DEVELOPMENT DETERMINATION PANEL MEETING

**ITEM 3.1 MOD2024/0082 - 21 HEADLAND ROAD NORTH CURL CURL -
MODIFICATION OF DEVELOPMENT CONSENT DA2021/1734
GRANTED FOR DEMOLITION WORKS AND CONSTRUCTION OF A
DWELLING HOUSE**

APPLICATION FOR MODIFICATION ASSESSMENT REPORT

Application Number:	Mod2024/0082
----------------------------	--------------

Image 1: Wide angle standing view towards the south from front balcony

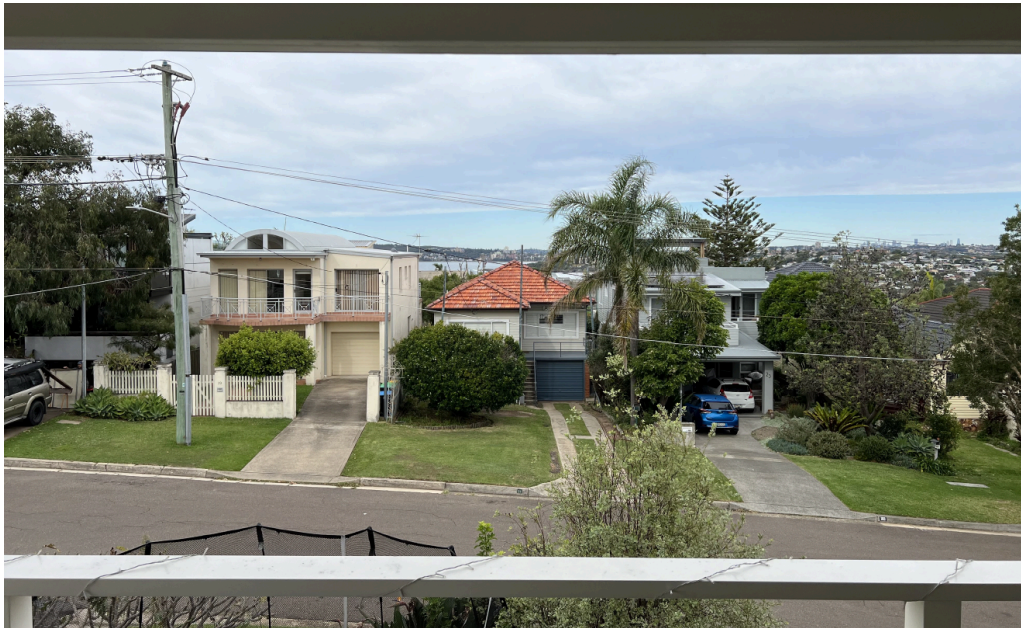
Views towards North Head and St Patrick's Seminary from the living area and balcony at the first floor of the dwelling at 20 Headland Road are obtained towards the south cross the front boundary through a corridor between the dwellings at 19 and 21 Headland Road. Water views

The building height, as approved by the Court, maintains the iconic elements of the view corridor from standing and sitting positions in the internal living area of the dwelling opposite the subject site. The proposed increased ceiling and building height will likely encroach upon the seminary building from a seated position in the living area. Views from a standing position are not expected to be significantly impacted.

It is expected that the proposed increase in building height will likely partially obscure St Patrick's Seminary and the surrounding vegetation curtilage when viewed from the southern living area and balcony of 20 Headland Road. As the framing of St Patrick's Seminary within the surrounding natural vegetation and bushland setting contributes to its iconic status, the partial obscuring of the vegetation curtilage affects the framing and integrity of the view of the seminary building. The development as currently approved will not cause as significant obstruction of the vegetation curtilage or seminary building. Due to the disturbance of the iconic element in this view corridor, the level of view impact of the proposed development is considered to be severe.

To ensure the view corridor towards the south is not further encroached upon, conditions are recommended to limit the first floor ceiling height and the overall building height to the RLs that were approved in the court development consent, that is RL 55.460 and RL 56.618, respectively. This means that no further view impact from the approved development will occur.
